2714 DUNSMUIR, CUMBERLAND

HERITAGE ALTERATION PERMIT AMENDMENT COMPARISON TO PREVIOUS DESIGN

2022.09.06

ROOF PLAN

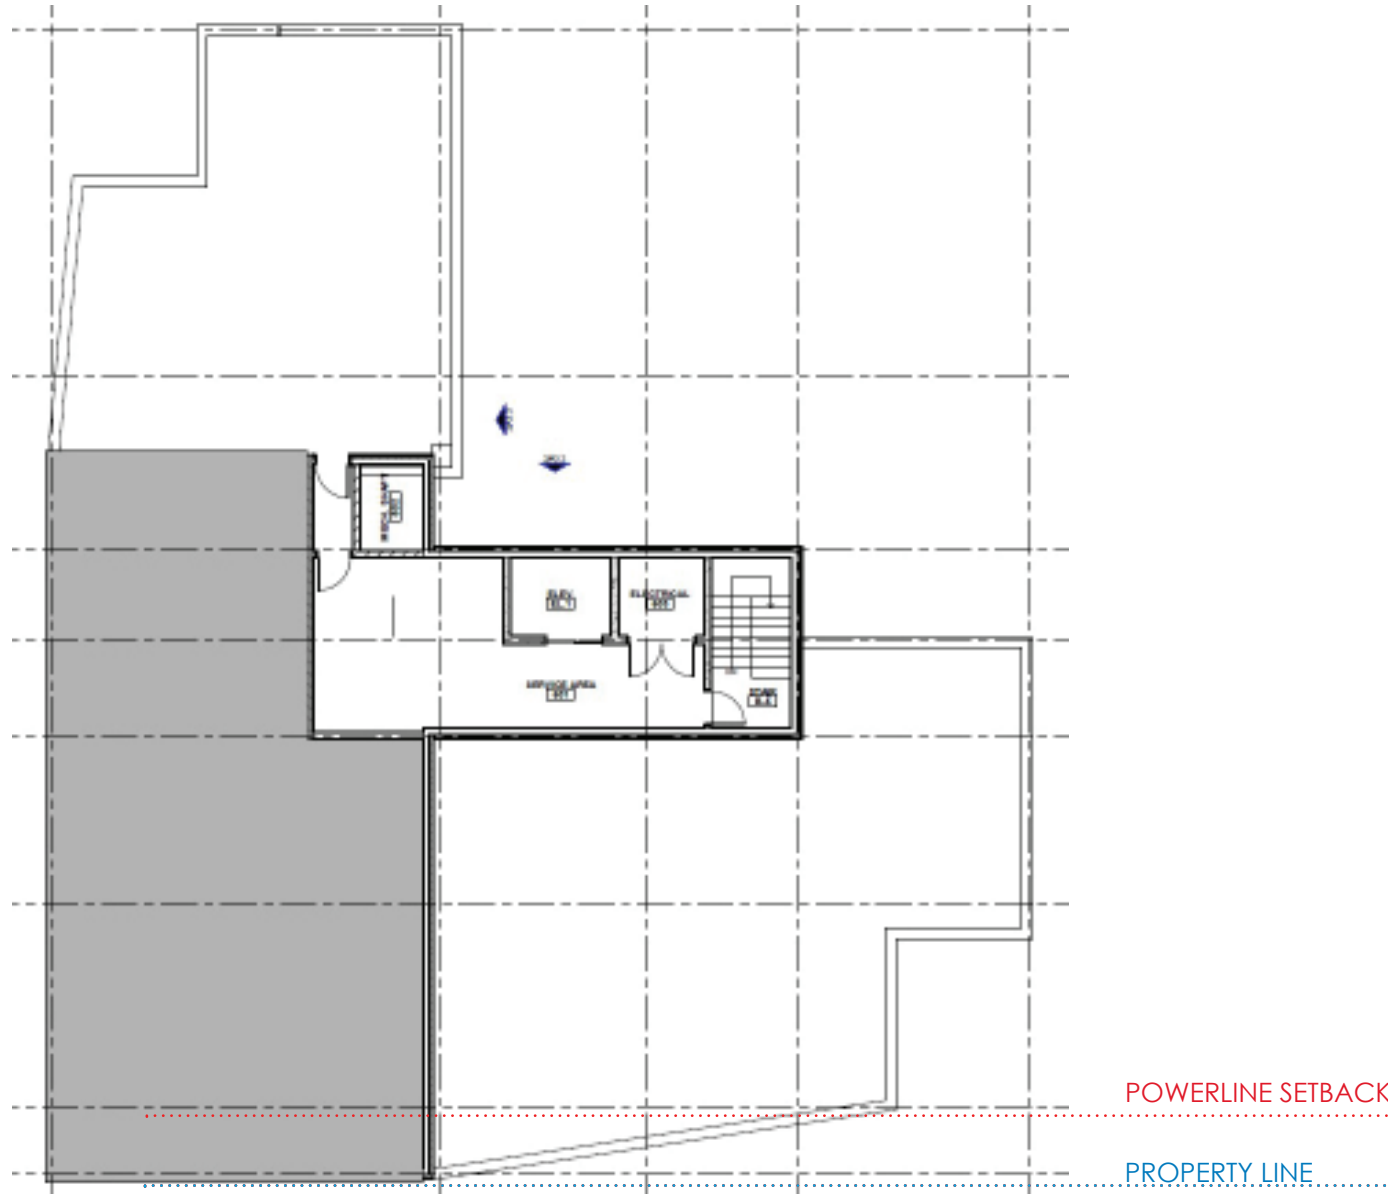
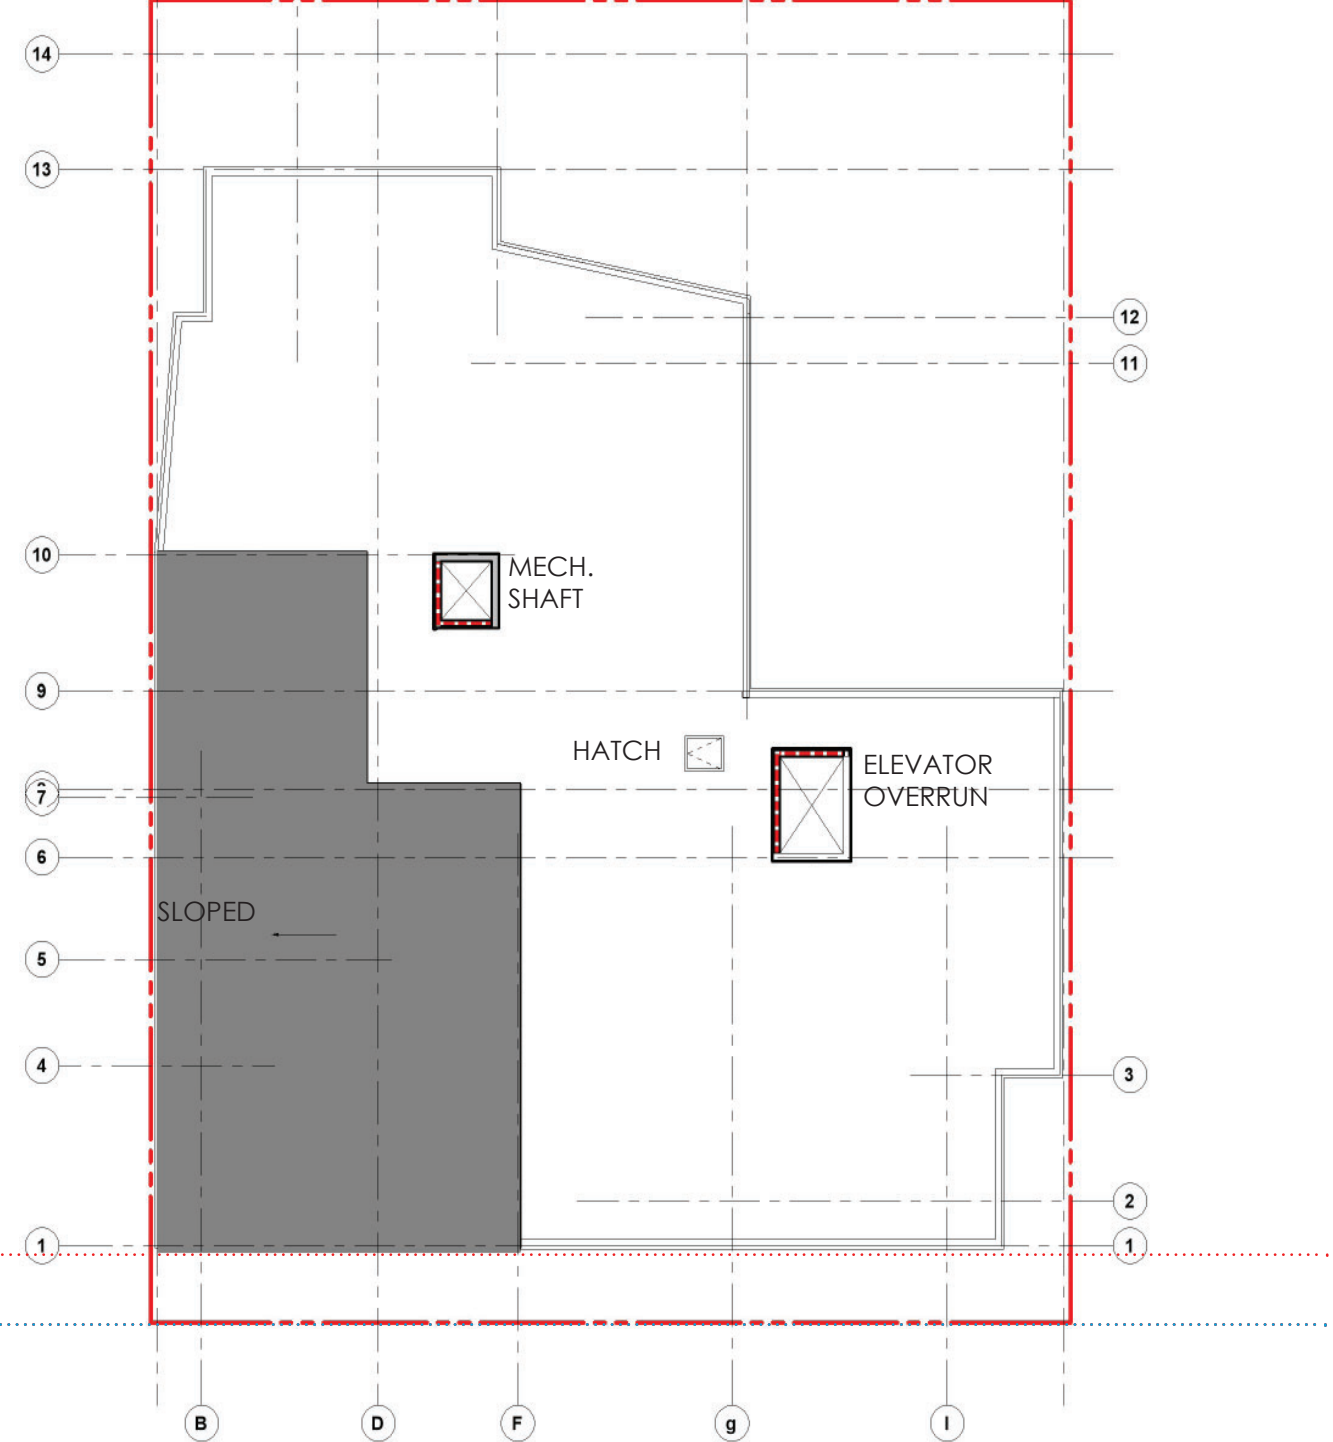
FLOOR AREA AS BEEN REDUCED TO ONLY THE SLOPED ROOF, MECHANICAL SHAFT AND THE ELEVATOR OVERRUN. ROOF IS ACCESSIBLE BY LADDER WITH ROOF HATCH

ELEVATION CLADDING

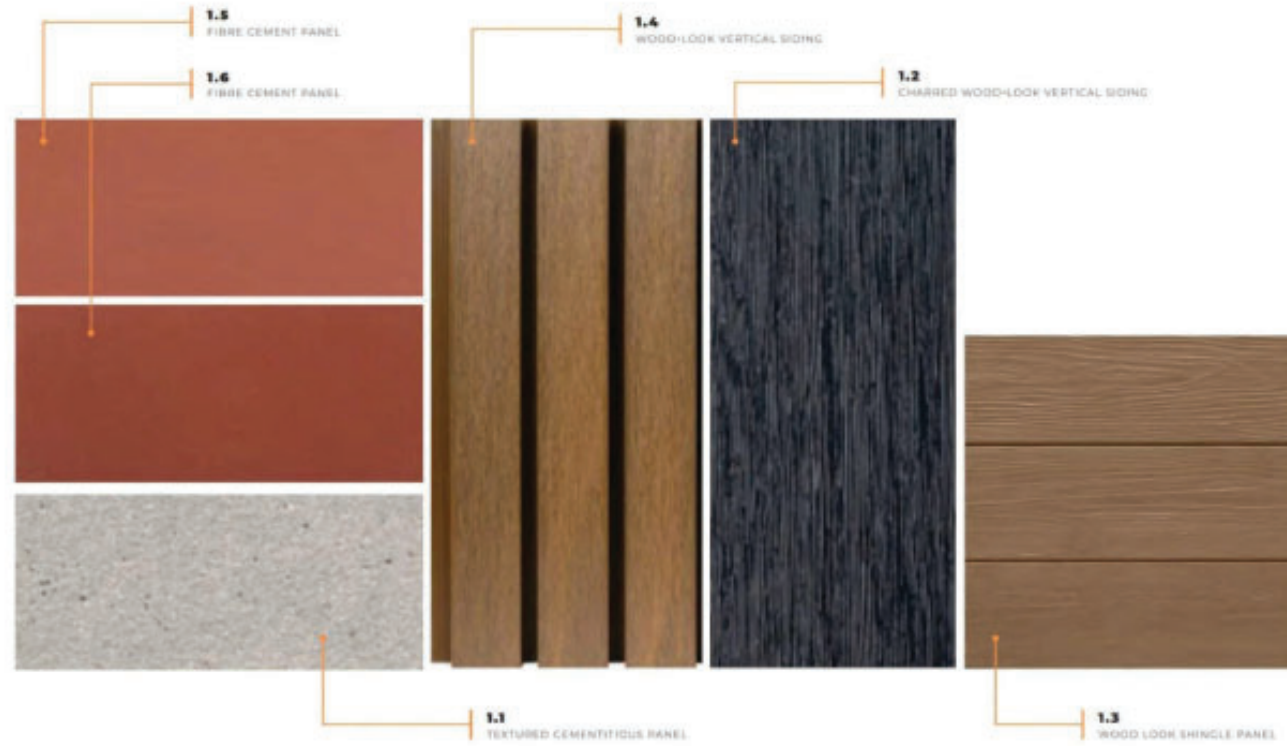
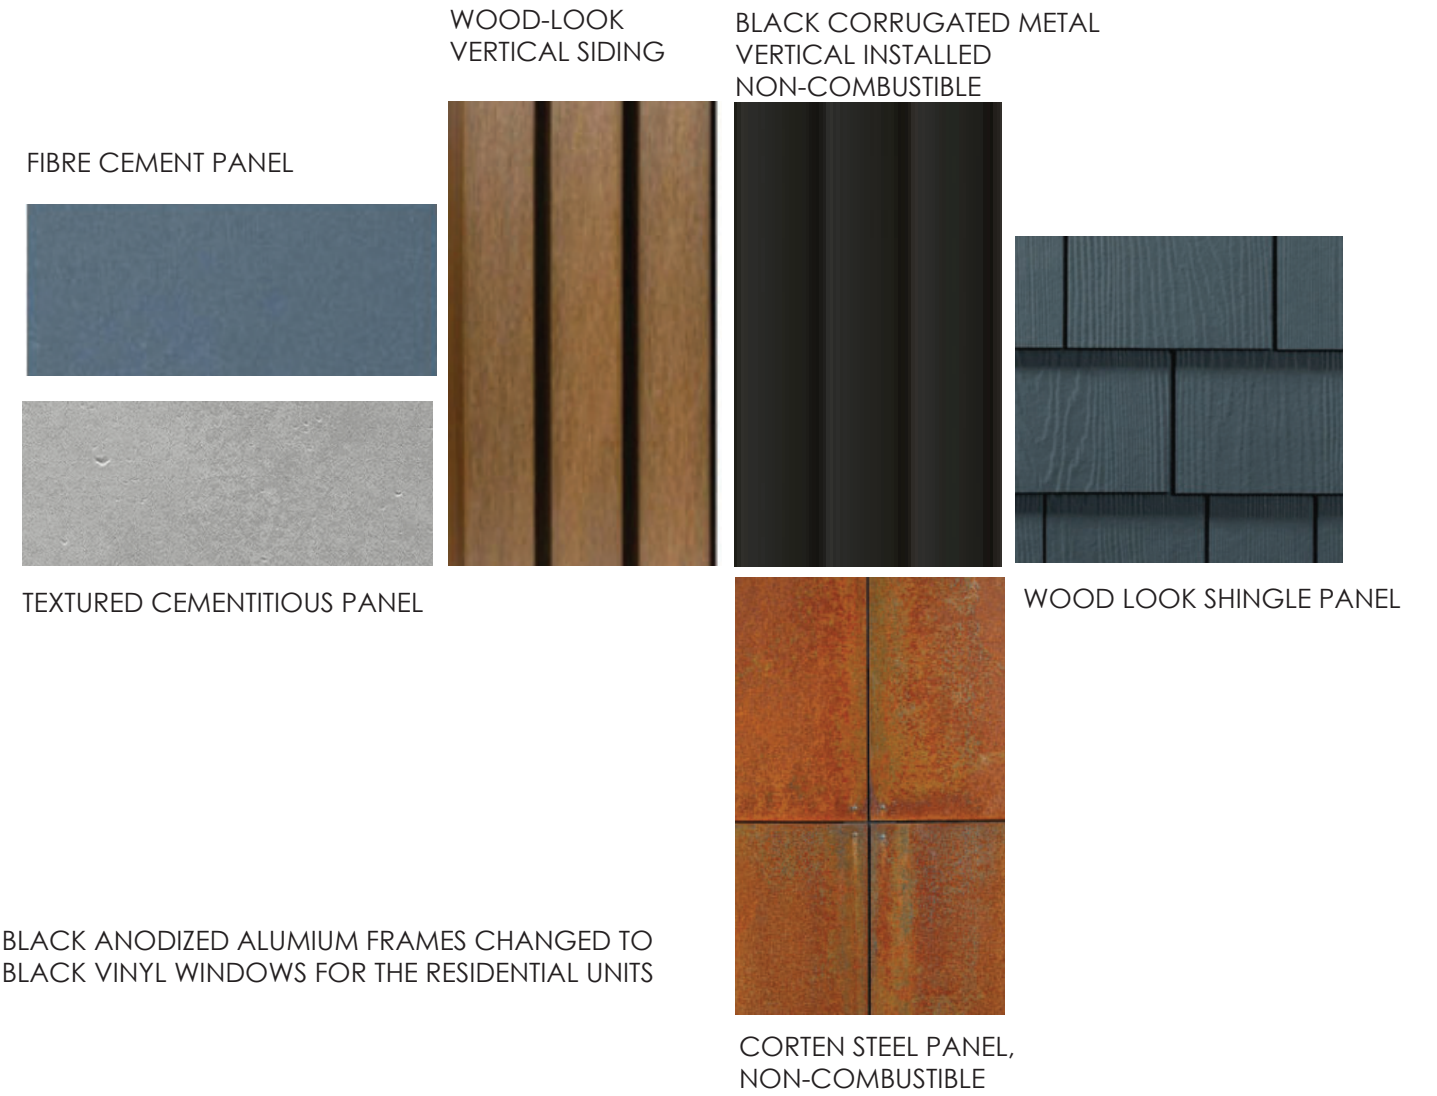
CLADDING CHANGED TO SHINGLES
INSTEAD OF VERTICAL SLATS

CHARED WOOD LOOK VERTICAL SIDING
CHANGED TO BLACK CORRUGATED
METAL, VERTICAL INSTALLED

BLACK ANODIZED ALUMIUM FRAMES
CHANGED TO BLACK VINYL WINDOWS FOR
THE RESIDENTIAL UNITS
